Access Compliance Report

Public Rights-of-Way

(Curb Ramps)

Intersection ID: 50591	Main Street: GREEN_GRASS_RD	Cross Street: LONGSTRAW_RD	Location: SE
ADA ID: A633DACFC5B4	Ramp Type: Perp	Initial Pass/Fail: Fail	Overall Compliance: No
Severity Score: 10			
Codes/Mitigation Info/Possible Solution		Field Measurements/Component Compliance

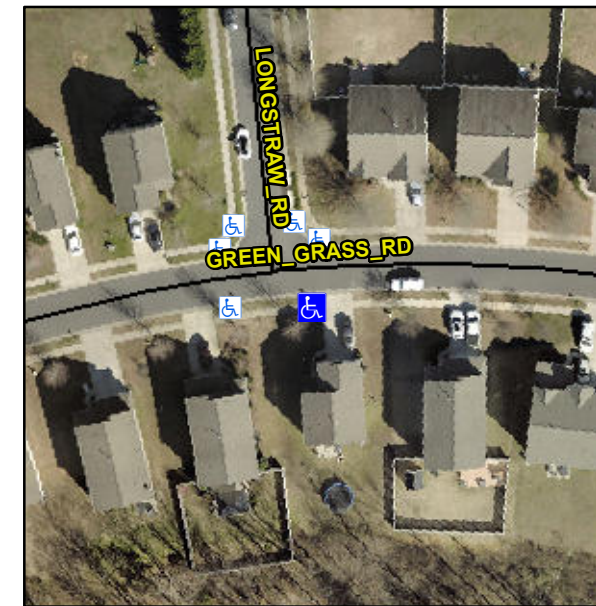
R304.5.1, R304.5.3

Compliance	Description	Data	Compliance	Description	Data
N/A	Ramp Length (in)	47.5	Yes	Ramp Slope (%)	8.2
No	Ramp Width (in)	45.5	No	Ramp XSlope (%)	3.7
N/A	Flare Type LT	N/A	N/A	Flare Type RT	N/A
N/A	Flare Slope LT (%)	N/A	N/A	Flare Slope RT (%)	N/A
N/A	Flare Traversable LT?	N/A	N/A	Flare Traversable RT?	N/A
N/A	Landing Length (in)	N/A	N/A	DWS Provided?	N/A
N/A	Landing Width (in)	N/A	N/A	DWS Contrast?	N/A
N/A	Landing Slope (%)	N/A	N/A	DWS Length (in)	N/A
N/A	Landing X Slope (%)	N/A	N/A	DWS Full Width?	N/A
N/A	Landing Curb? (Y/N)	N/A	N/A	DWS Offset (in)	N/A
N/A	Shared Landing?	N/A			
N/A	Gutter Ponding?	N/A	N/A	Gutter Slope (%)	N/A
N/A	Gutter Lip Ht (in)	N/A	N/A	Gutter X Slope (%)	N/A
N/A	Painted X Walk1?	No	N/A	Painted X Walk2?	N/A
	X Walk 1 Direction	To N		X Walk 2 Direction	N/A
N/A	X Walk 1 Width (in)	N/A	N/A	X Walk 2 Width (in)	N/A
	X Walk 1 Slope (%)	1.2		X Walk 2 Slope (%)	N/A
	X Walk 1 X Slope (%)	3.2		X Walk 2 X Slope (%)	N/A

Remove & Replace Entire Ramp.
